**ADDENDUM NO. 3
TO THE BID DOCUMENTS
FOR THE
ATCT RENOVATIONS PHASE II- GLASS REPLACEMENT
BOCA RATON AIRPORT
BOCA RATON, FLORIDA**

**ADDENDUM NO. 3
TO THE BID DOCUMENTS
ATCT RENOVATIONS PHASE II- GLASS REPLACEMENT
BOCA RATON AIRPORT
BOCA RATON, FLORIDA**

Addendum #3 – Bidder's Questions

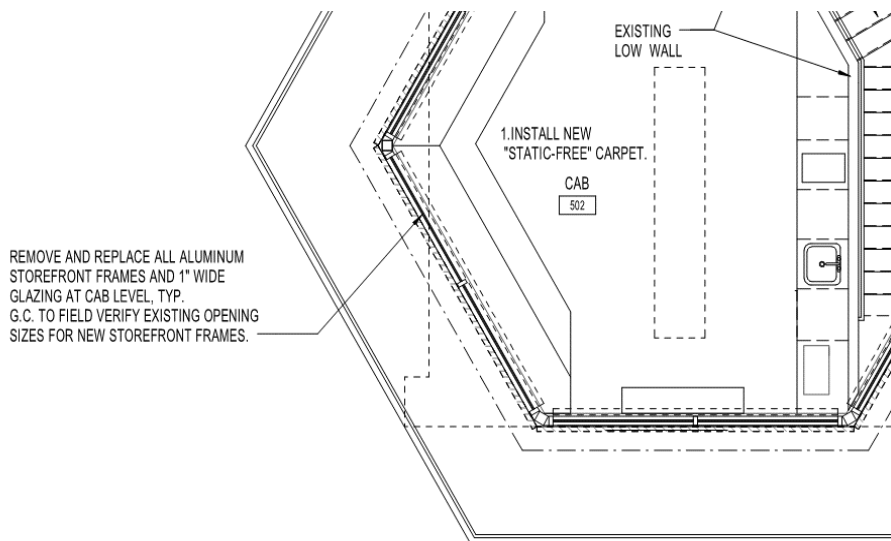
Q: In addition to the removal of the motorized hurricane shades, is the remaining removal just the aluminum frame and glass?

A: Contractor to remove **JUST** the aluminum frame and glass and the hurricane shutters. As shown in these notes and demo plan.

REMOVE EXISTING MOTORIZED HURRICANE SHUTTERS, TRACK & HARDWARE AND TURN OVER TO OWNER.
* REPAIR/ REPLACE EXTERIOR WALL PANEL SURFACES BEHIND HURRICANE SHUTTERS HOUSING TO MATCH ADJACENT. DISCONNECT ELECTRICAL ASSOCIATED, SEE ELECTRICAL.
